4.0 PROPOSED DEVELOPMENT

PRINCIPAL CHANGES:

FIG. 49 - PROPOSED MASTERPLAN SHOWING BLOCK A ROTATED 90 DEGREES

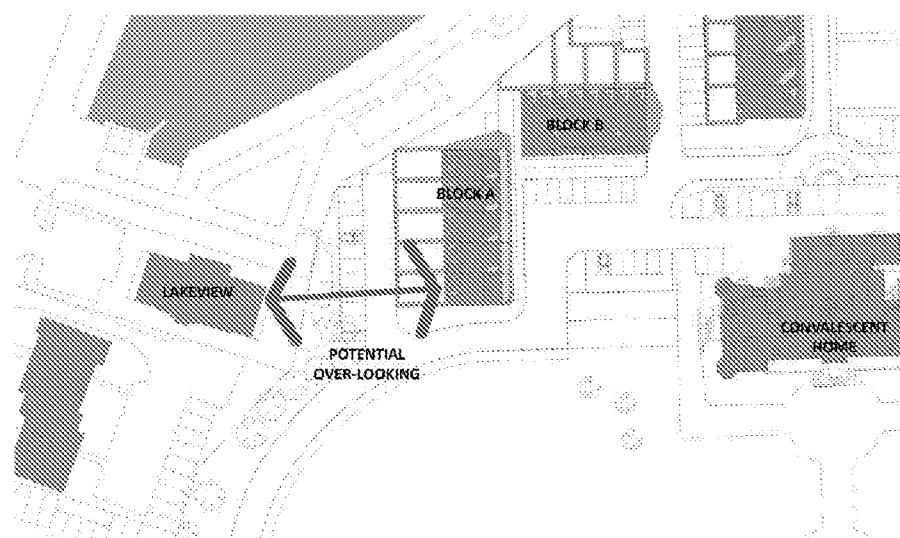
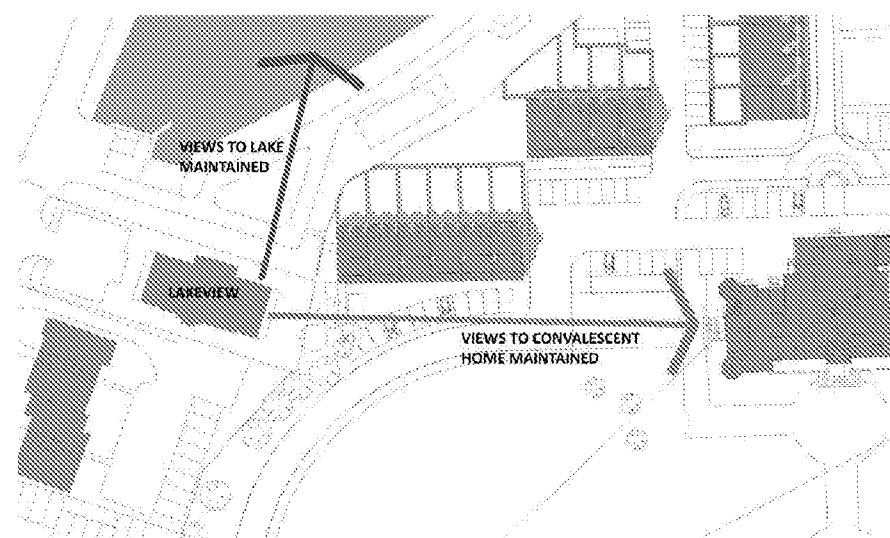
- 4.2 Block A rotated 90 degrees to face south and 1 house added to this block.

The orientation of the consented block means that the rear windows of the new houses face the existing adjacent Lakeview apartment building (see Fig. 48) This was noted as a reason for objection by some of the residents due to loss of privacy.

The diagrams here show that rotating the block removes this conflict, provides clearer views of the convalescent Home (as Lakeview residents currently enjoy) and does not impact on views of the boating lake to the north. (See Fig 49).

FIG. 51 - PROPOSED AMENDMENT TO ROAD JUNCTIONS

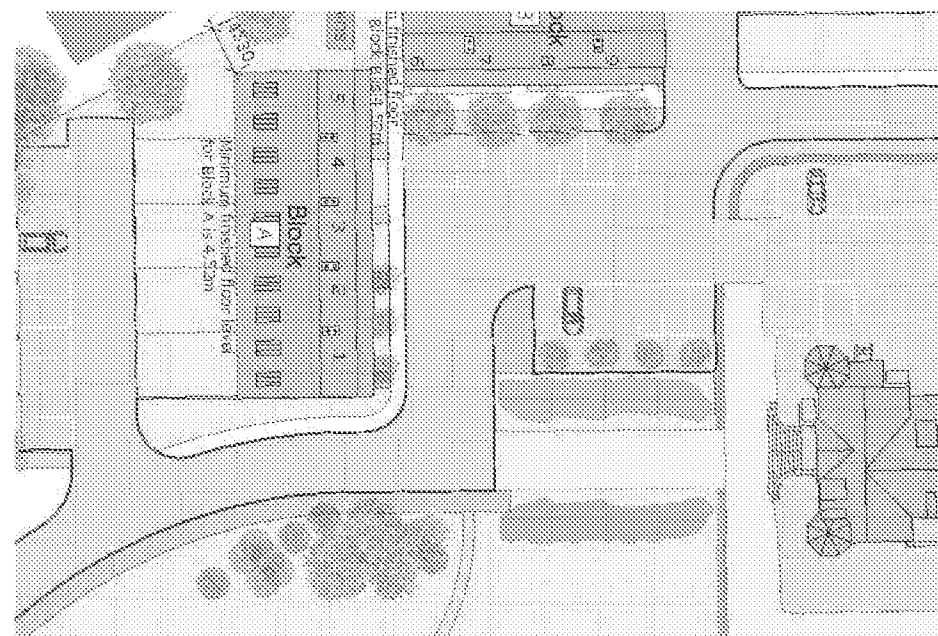
- 4.3 Road layout on West side of Convalescent Home amended.

The consented road junction giving access to parking at the rear of the Convalescent Home and to other areas of the new development consists of a sequence of 4 right angle bends (see Fig. 50). This creates some unusual road spaces and provides for very difficult manoeuvres for refuse lorries and other large vehicles.

The proposed amendment simplifies this arrangement making it easier for all road users to understand and avoids potential pedestrian/vehicle conflicts through provision of additional footways but still creates a chicane feature to reduce vehicle speeds (see Fig 51).

Note the proposed sub-station location at the rear of the parking spaces to the west of the Convalescent Home. This position will be screened by the existing retained shrubs here and will be sufficiently far from the surrounding buildings not to have a noise impact requiring mitigation.

FIG . 53 - PROPOSED BLOCK C

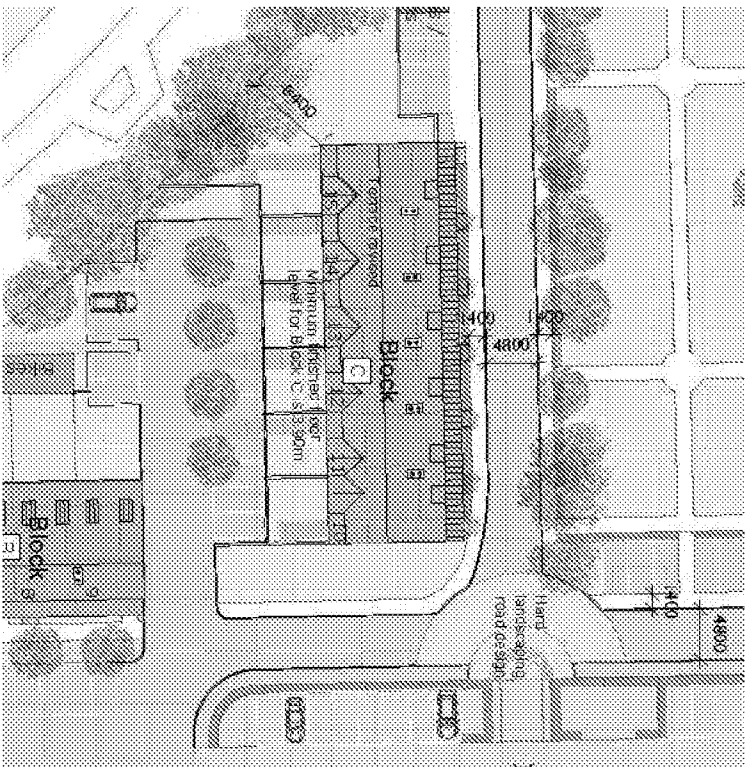
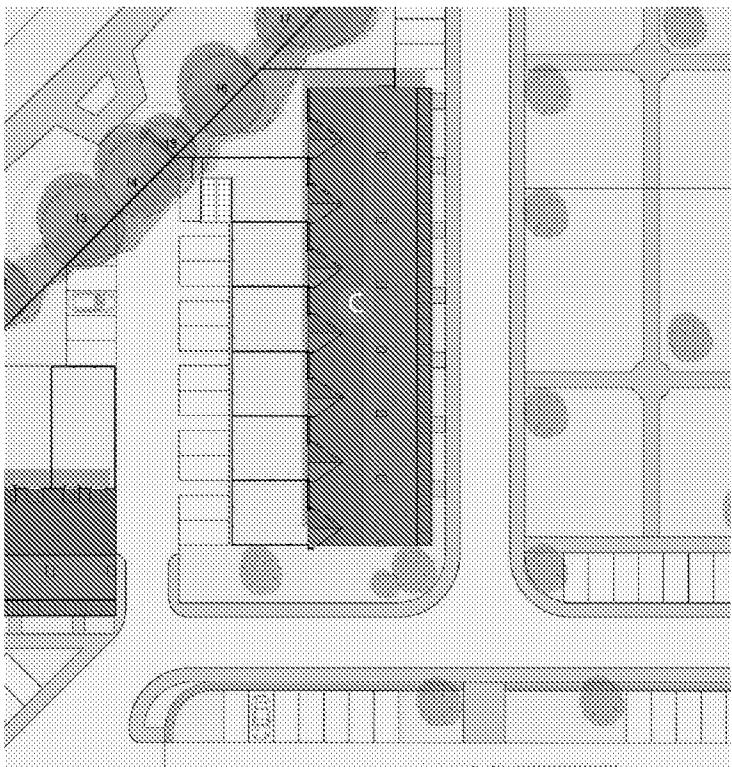
4.4 1 House added to the North end of Block C

There is ample space for an additional house in this location and its impact is minimal. It does not affect any existing houses nearby or provide any detrimental impacts within the development. It provides a better sense of enclosure to the west side of the formal green space in the middle of the plan.

Fig. 52 shows the consented block arrangement and Fig. 53 shows the proposed.

FIG . 55 - PROPOSED BLOCK D

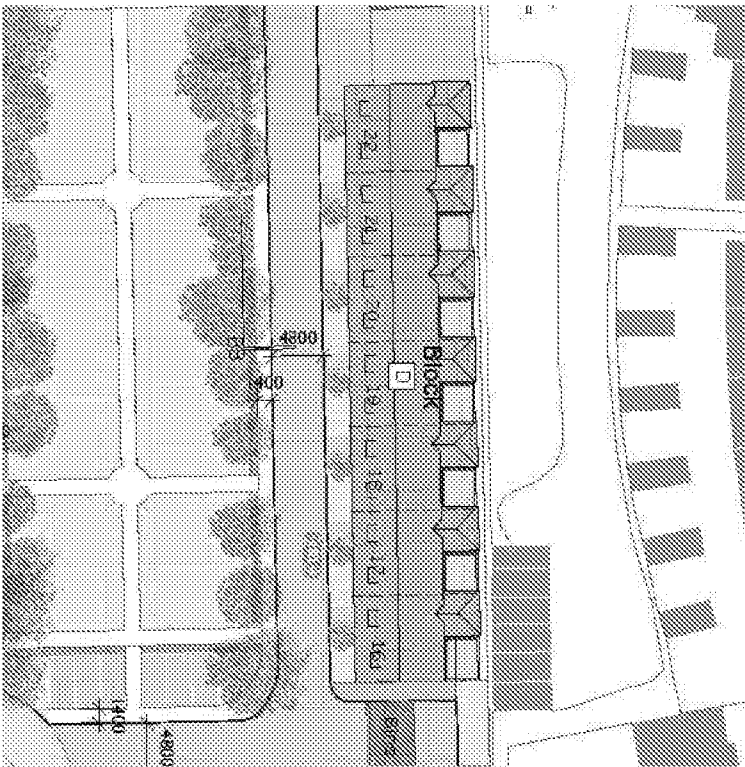
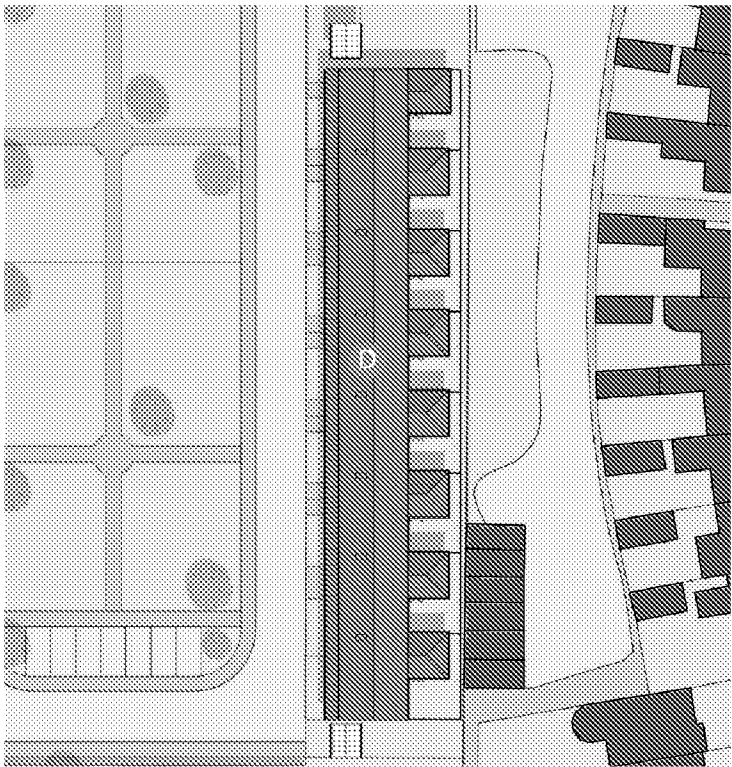
4.5 1 house added to the south end of Block D and block moved 1.5m west, away from the site boundary

The consented plan (Fig. 54) includes a communal bin store at the south end of this block- this cannot be used for this purpose as a number of the houses would be too far from this store to comply with Building Regulations (Approved Document H6 para. 1.8). For this reason we propose to provide individual bin stores to houses (as purchasers would normally expect) so this bin store becomes redundant. (Refer to item 4.7 below for further detail).

Providing a house here instead creates a better entrance to this area of the development- the house forms a visual stop to the access road running from west to east at the south end of the formal garden. The block is of sufficient distance from the Convalescent Home that it would not impact on its setting.

The repositioning of the block provides some mitigation of the very small gardens to these houses. It is accepted that they benefit from the formal gardens in front of them but this additional space will make the more saleable. This repositioning also has the benefit of moving the houses further from the existing houses of the Martlets, where residents have objected to the proximity of the new buildings.

FIG. 57 - PROPOSED BLOCK E AND F

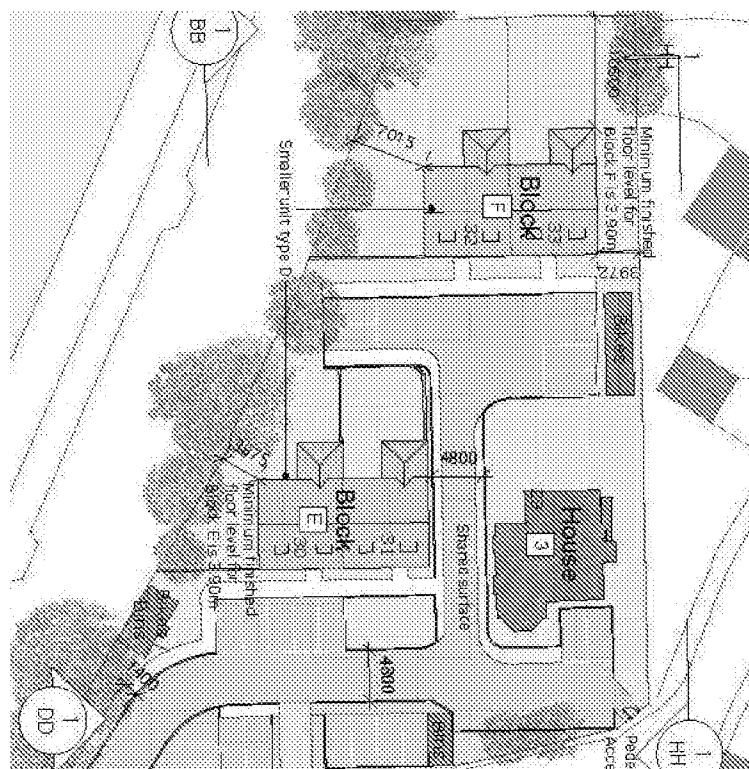
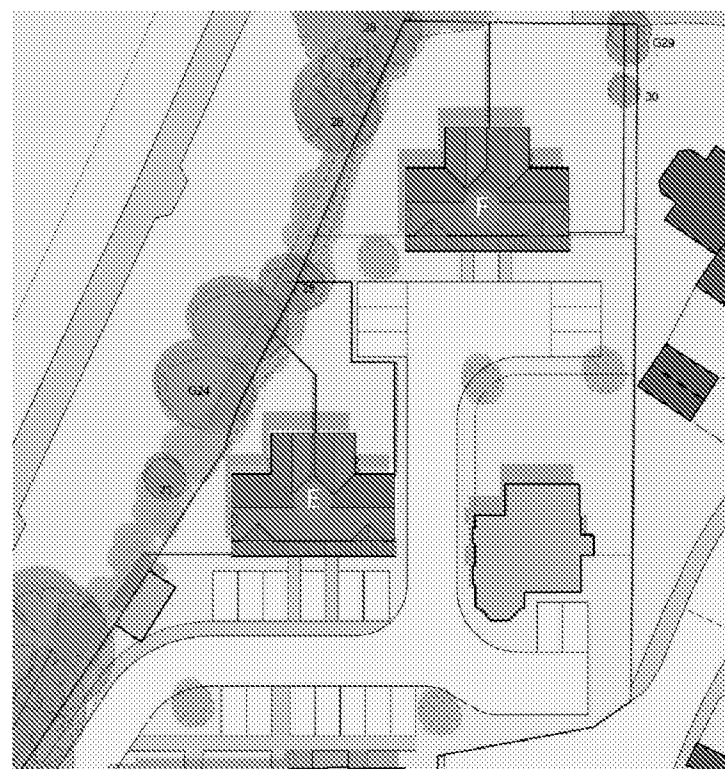
- 4.6 Blocks E and F paired to create semi-detached houses and increased in size to 3 bed houses.

The consented layout (Fig. 56) shows that these two blocks are effectively terraces of 2 houses (ie repeated rather than handed). This is an unusual typology and we believe that mirroring them to make them into pairs of semi-detached houses is more in keeping with the suburban aesthetic (Fig. 57).

This also ensures that both houses in a pair have good relationships with their gardens – the living/dining spaces look outwards rather than one type looking into an enclosed courtyard

These houses have very generous gardens and have a close relationship to the family houses in the Martlets immediately adjacent. For these reasons we believe these should be 3 bedroom family houses rather than the 2 bedroom house types as consented. This increased size is achieved by adding a room above the kitchen projection at the rear, which has little impact on the neighbours. This change to Blocks E and F will make them more saleable and achieve higher values.

FIG. 59 - EXAMPLE BIN STORES TO FRONT OF BLOCK E

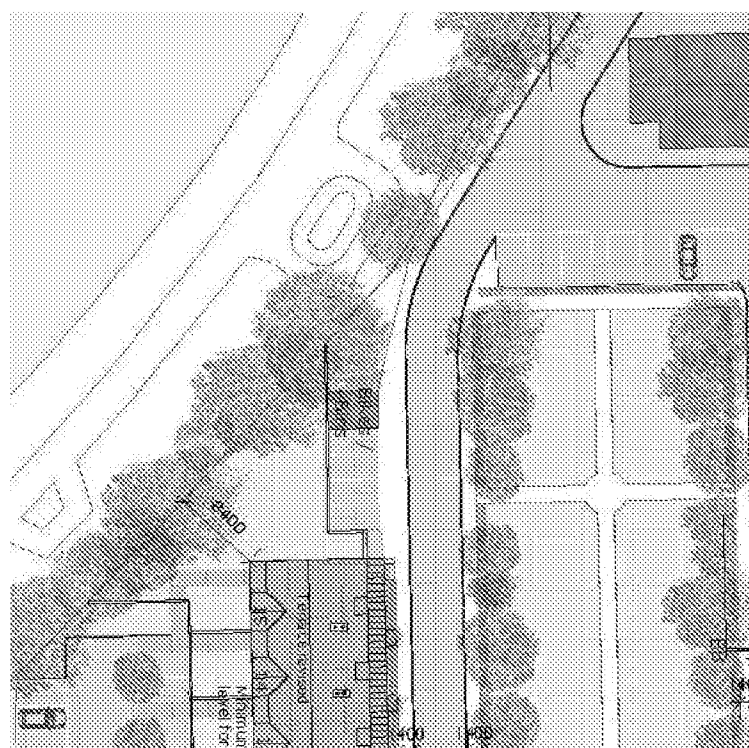
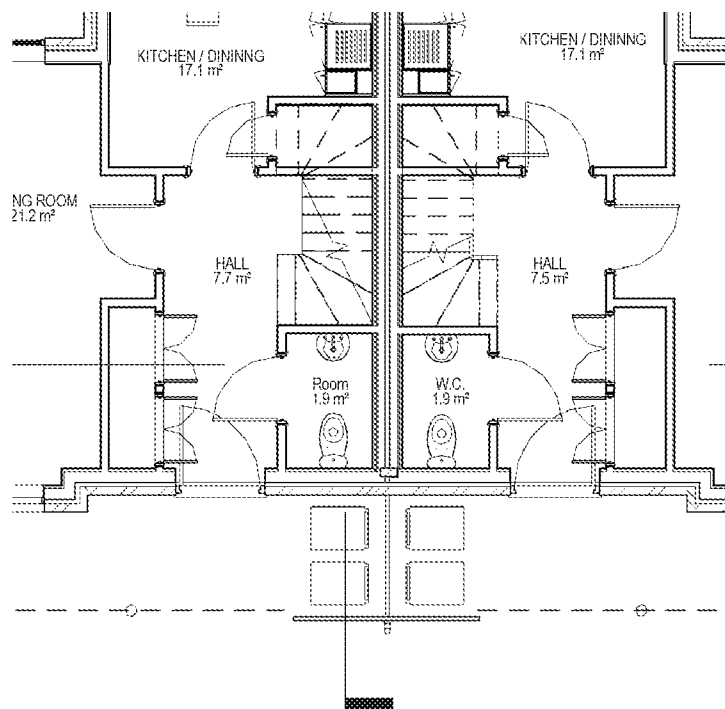
- 4.7 Amendment to Waste strategy by removal of communal refuse stores to houses.

The consented scheme includes a number of communal refuse stores for the blocks of houses. It is usual for houses to have refuse storage within their own curtilage so we have proposed to remove the communal refuse storage from all but the flats. Instead refuse storage is in a purpose-designed space next to the front door of each house, protected by the canopy at the front.

A vertical timber wall to the front screens the bin stores from the street and gives a uniform appearance. (The screen could be used for house numbering or postal addresses). Behind this screen a standard bin store will be used to fully enclose the waste and recycling bins. The space above the bin store up to the canopy ceiling will be open where appropriate so that there is still a good level of light around the front door. (Refer to section 4.18 below for further detail of storage and collection strategies).
